Development Permit Panel

Wednesday, January 15, 2014

2. Development Permit 12-617455

PROPERTY LOCATION: 6511 No. 2 Road (formerly 6471, 6491, 6511 No. 2 Road)

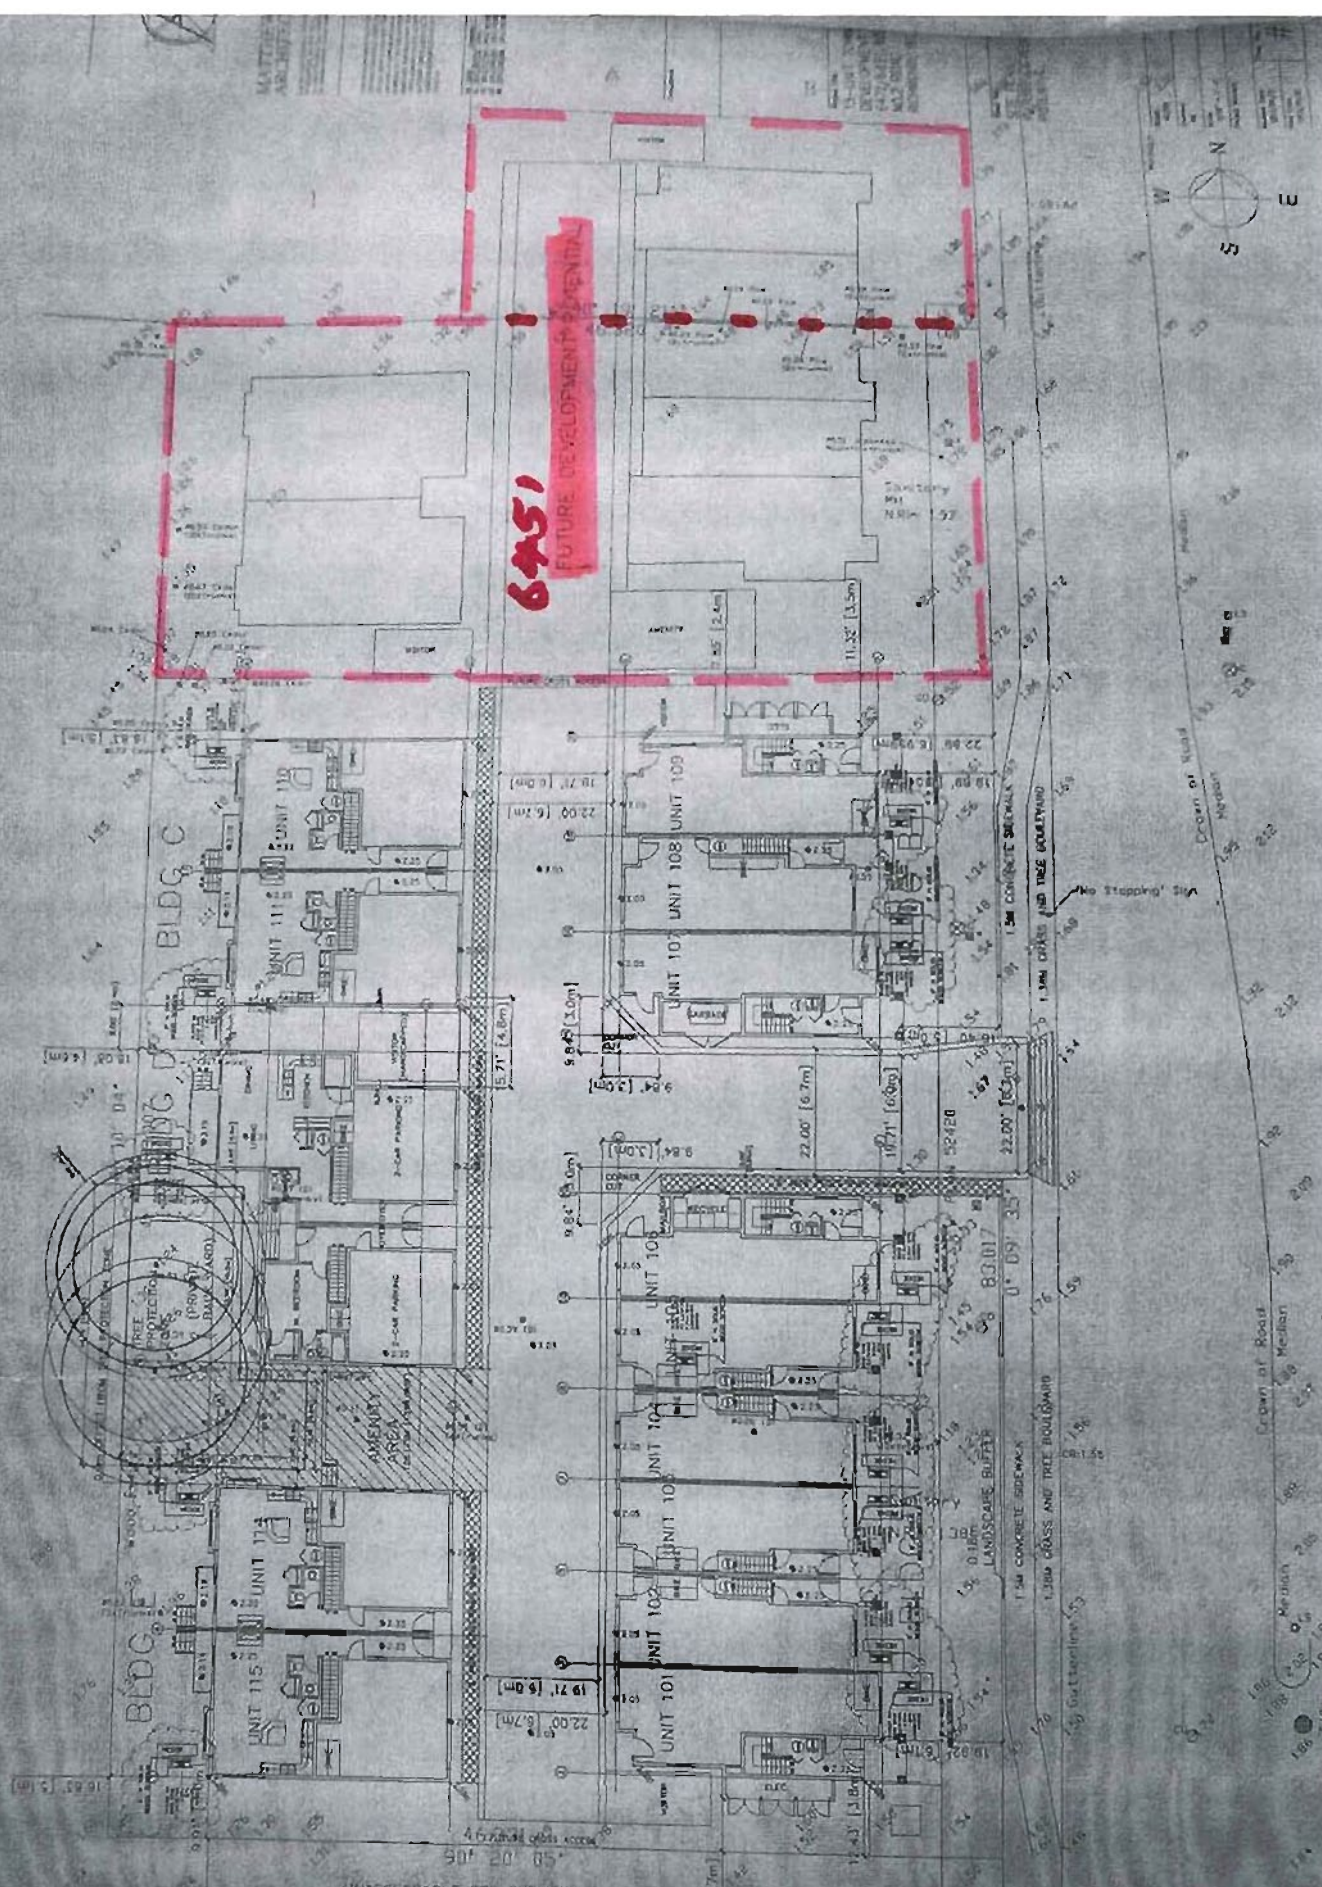
Has the Panel considered the future development of our lot which is of more or less the same size, same depth and same frontage of our adjacent pre-neighbor house lot? Our latest check with the future development plan from City map gives us a shock. Our lot development has to be combined with our North-bound neighbor with a much smaller lot with less frontage and less depth. (Please see picture No. 3...)

Therefore, we would request the Panel to consider accepting our single lot to be developed into Townhomes in future WITHOUT any conditions added. We have already got the general/common access from the 6511 No. 2 townhomes (PROPOSED) via No. 2 Road and this makes more sense for us to develop our present single lot into townhomes in future.

BUILDING A EAST ELEVATION (NO.2 ROAD)

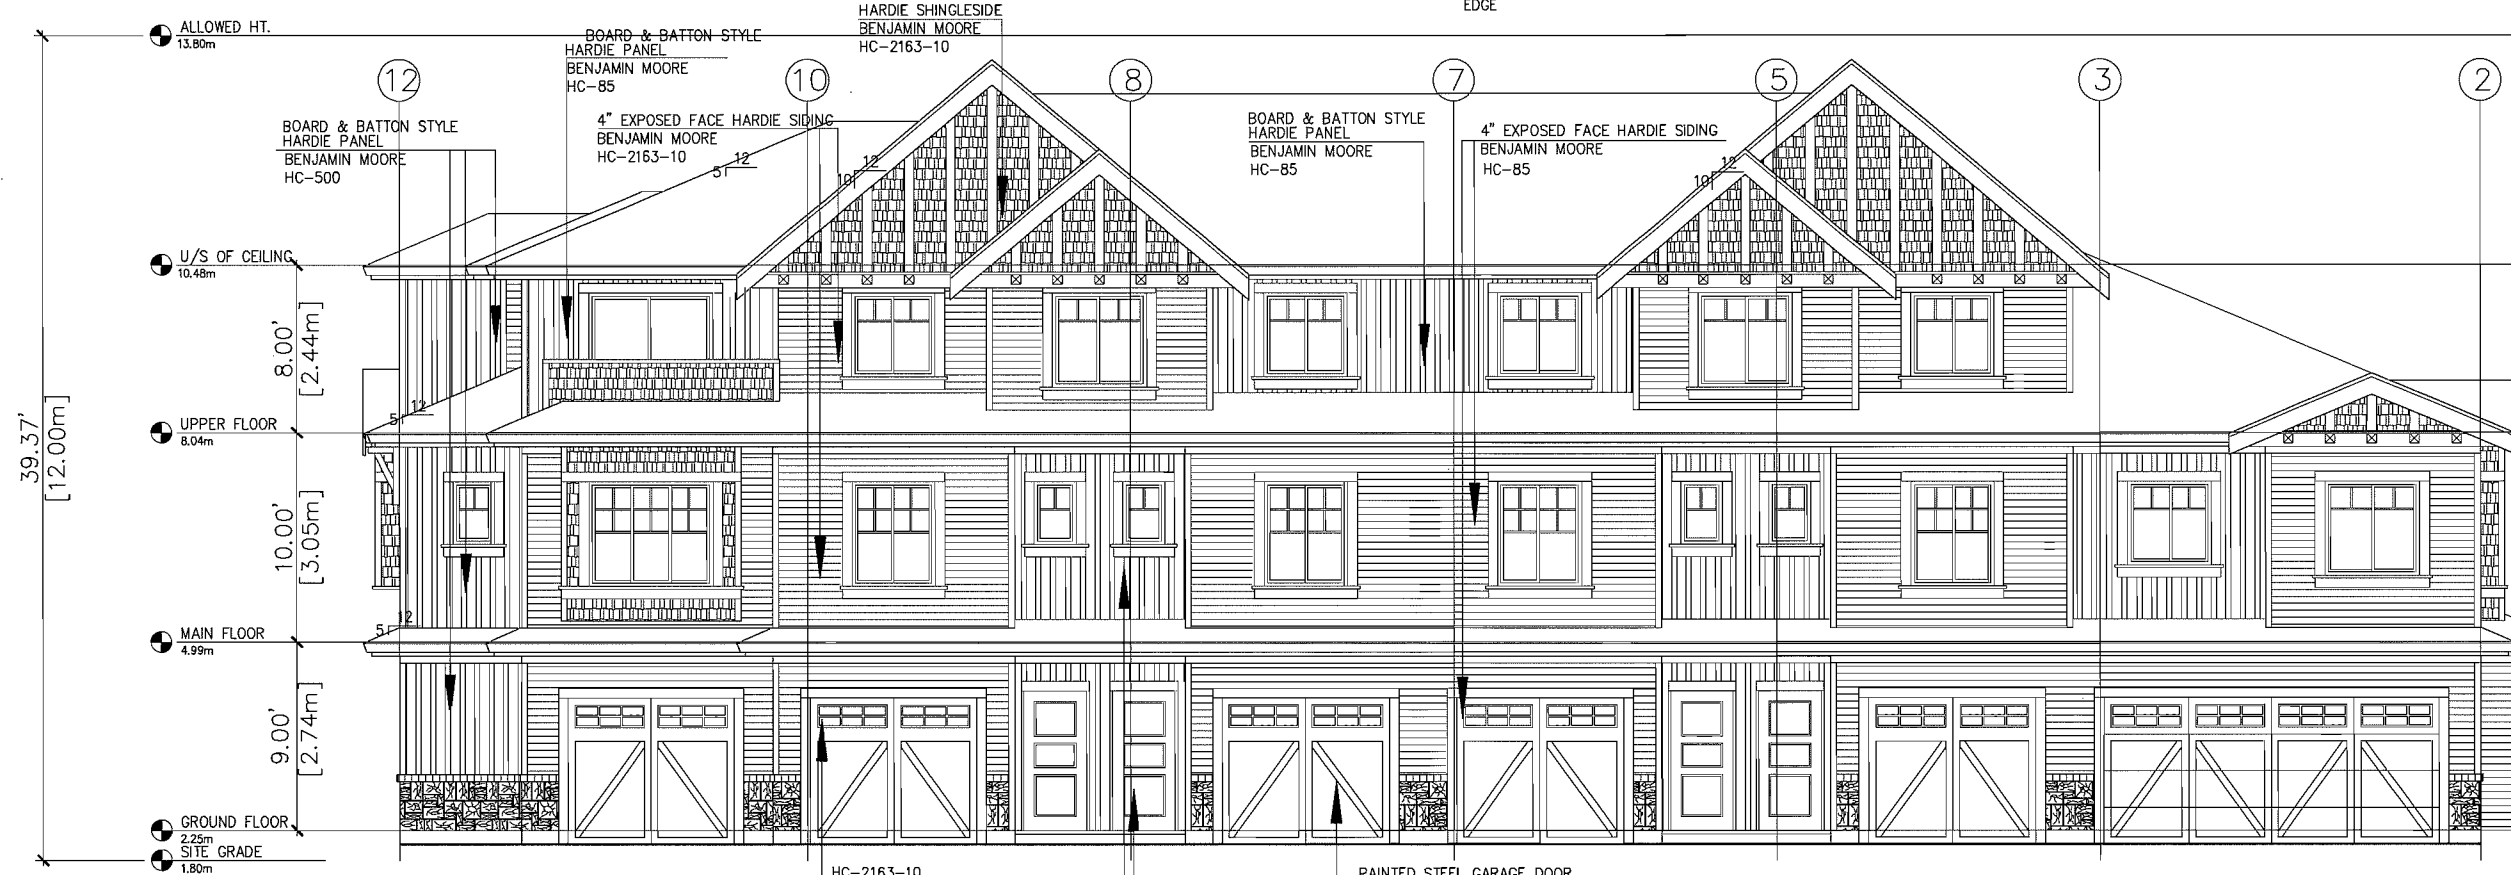
13. consider design development of units facing the interior driveway;
The north elevation of Building A and the south elevation of Building B have been revised with more windows and articulations.

16. elevations of the end units appear a bit austere; applicant could use some more glass;
The north and south elevations of Building A and B have been revised with more windows.

23. additional gable windows may be appropriate for units along the internal drive aisle but not for the end units of the street fronting buildings as they are facing other houses;
Gable windows have been added to these elevations: Building A North, Building D East, Building B South and Building B West.

BUILDING B WEST ELEVATION

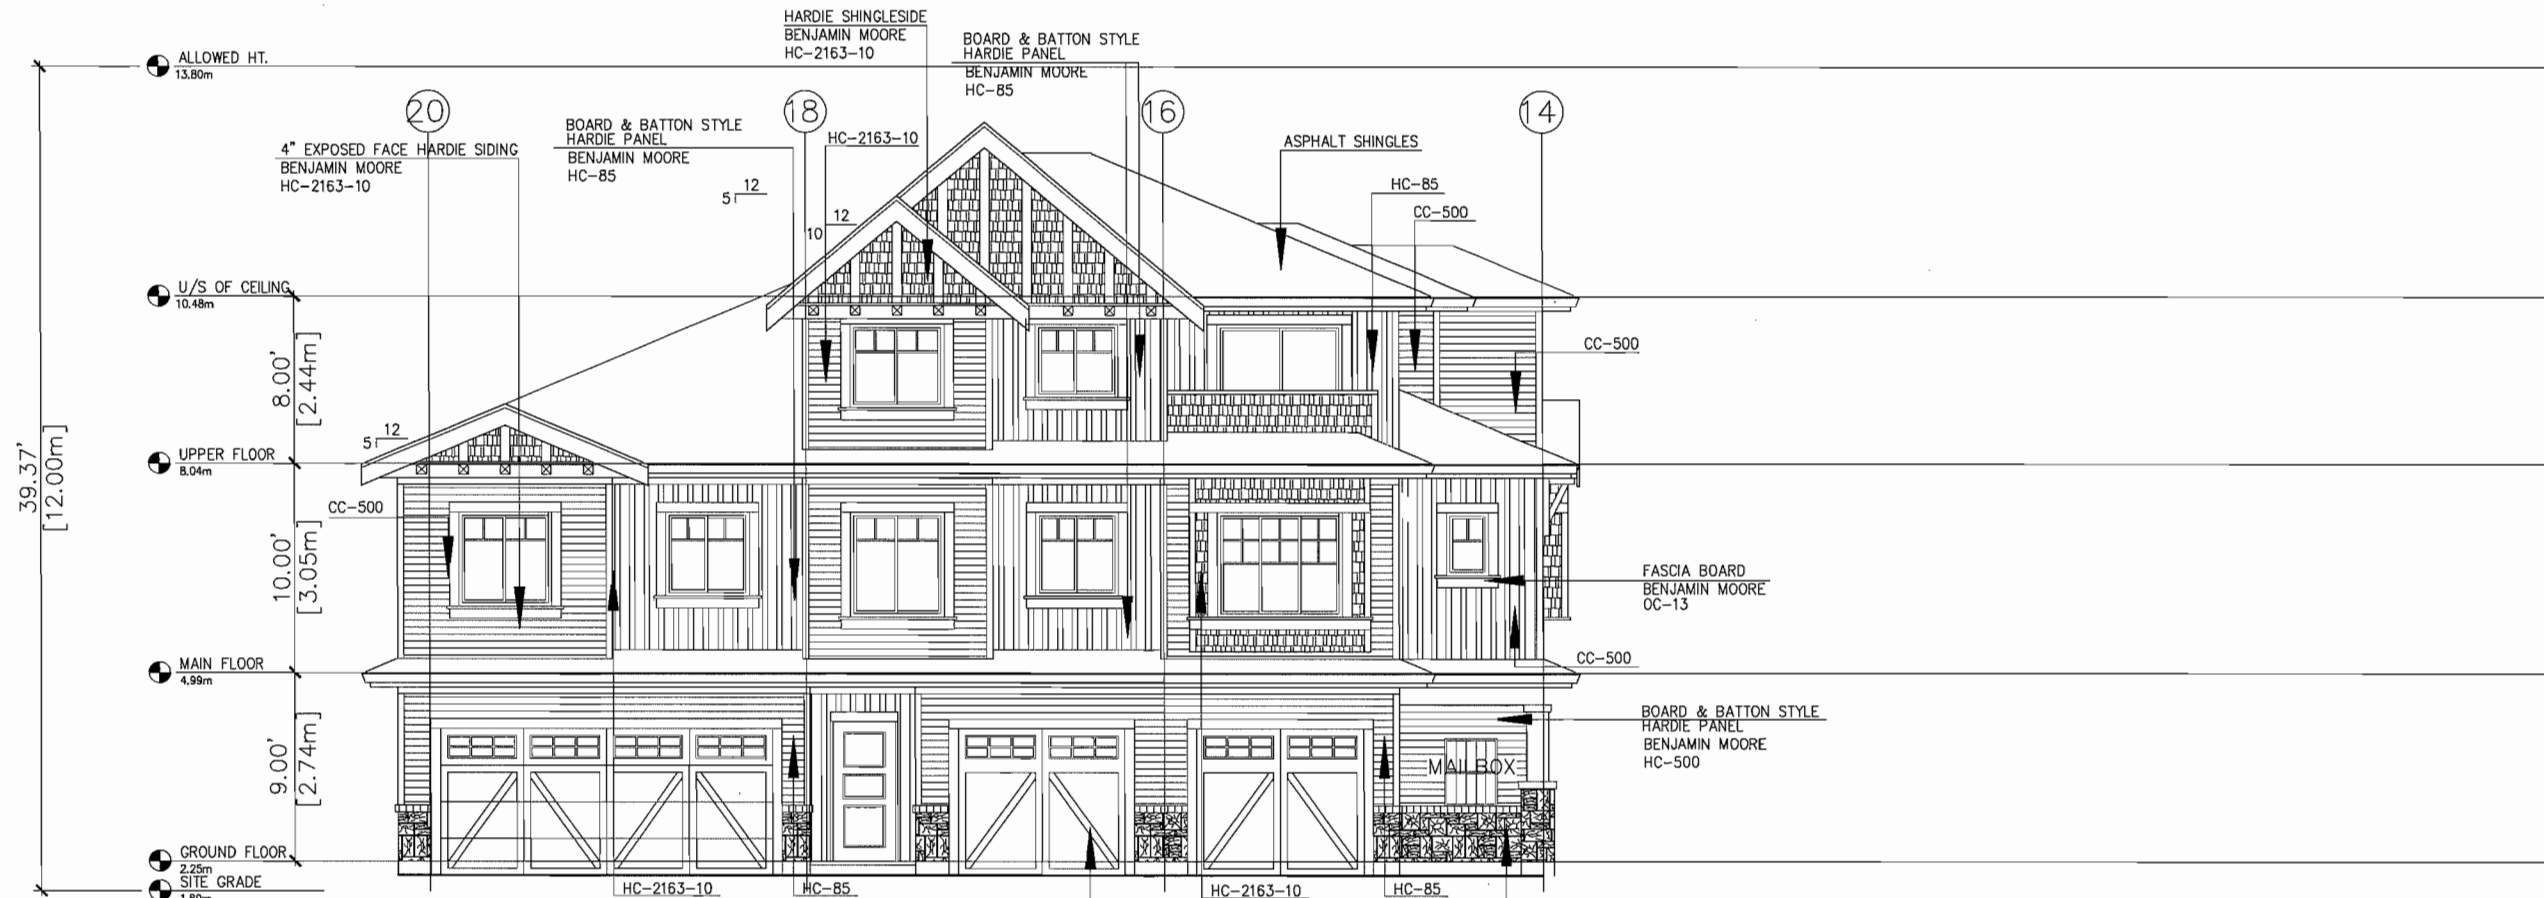
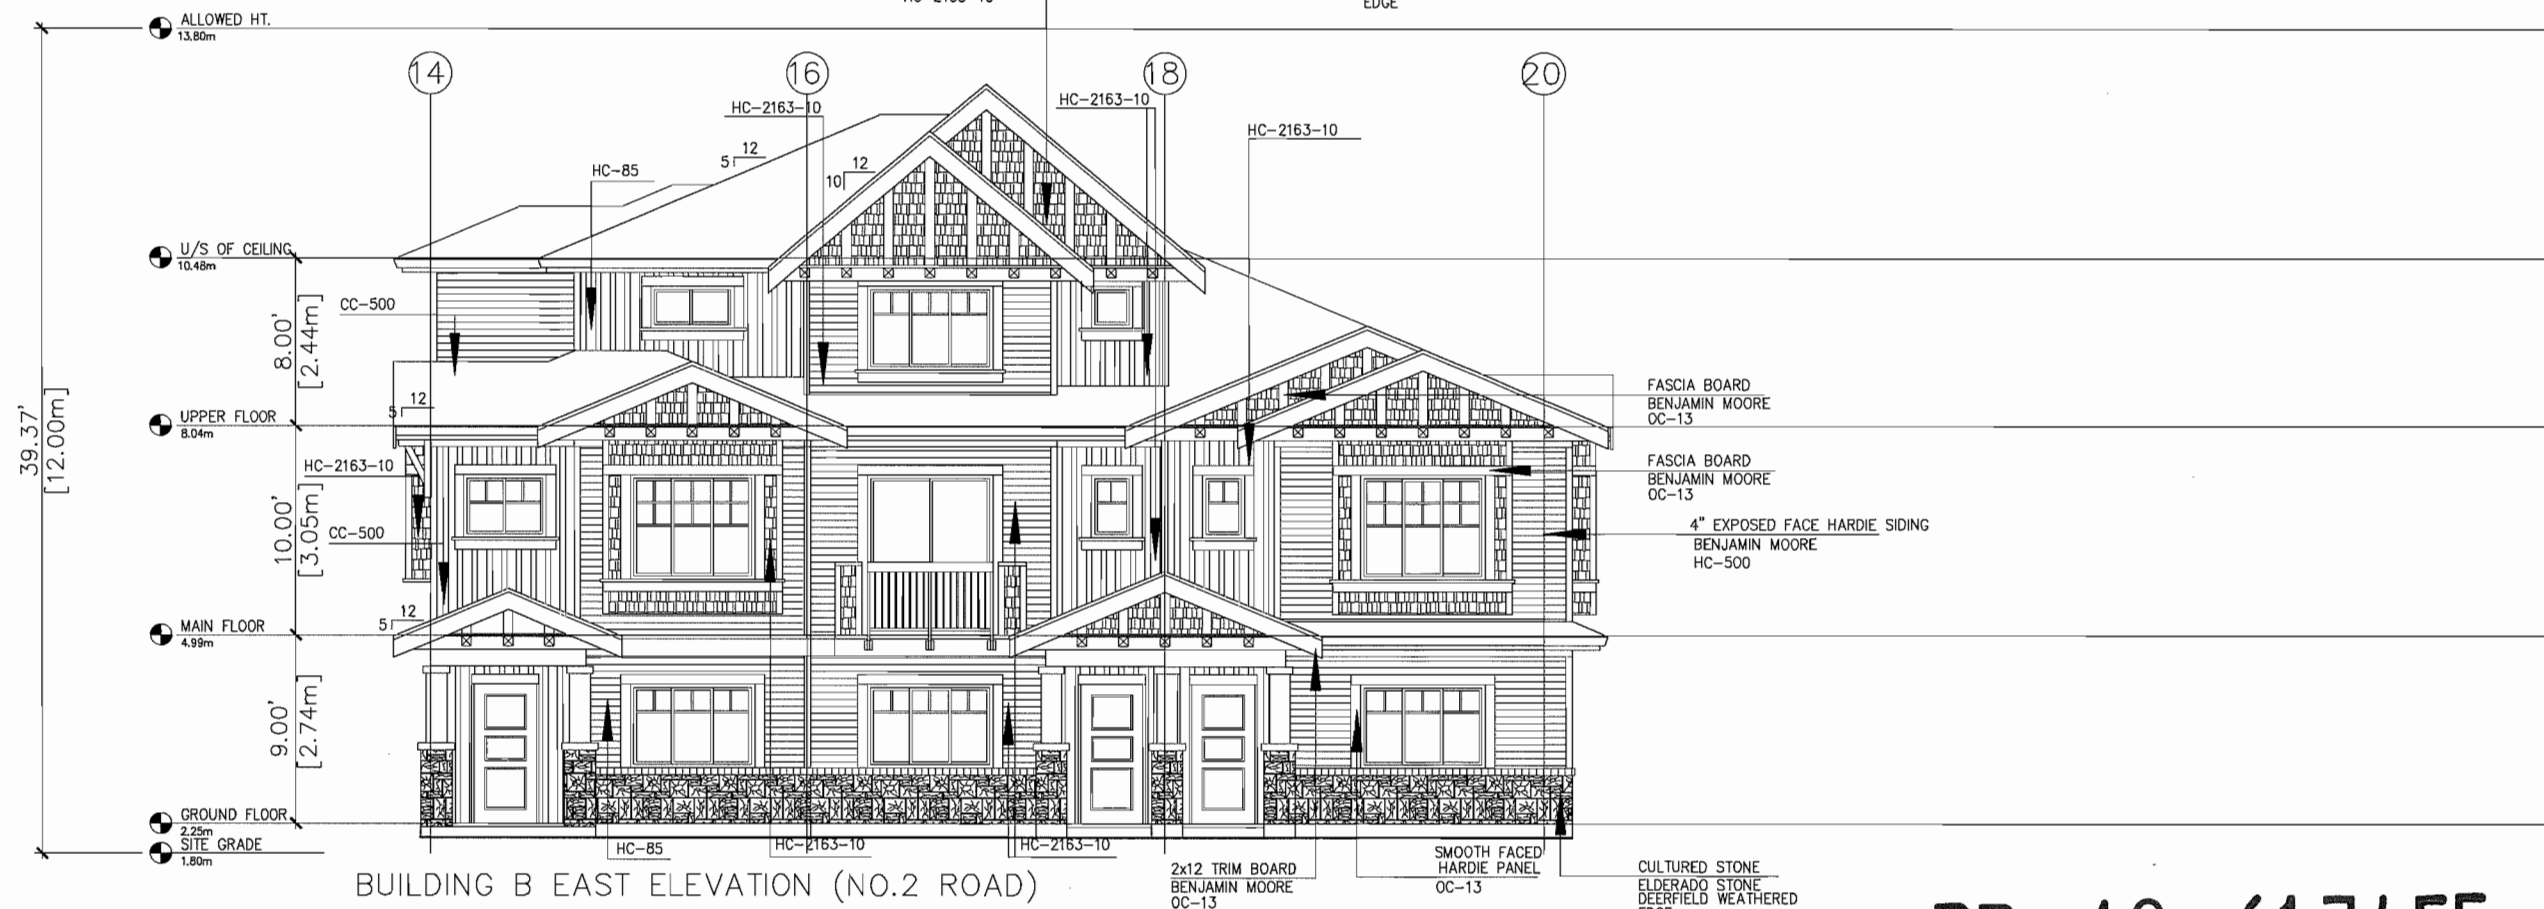
19. consider enhancing the treatment of ground floor units along the interior driveway;
The north and south elevations of Building A and B have been revised with more windows.

The north and south elevations of Building A and B have been revised with more windows.
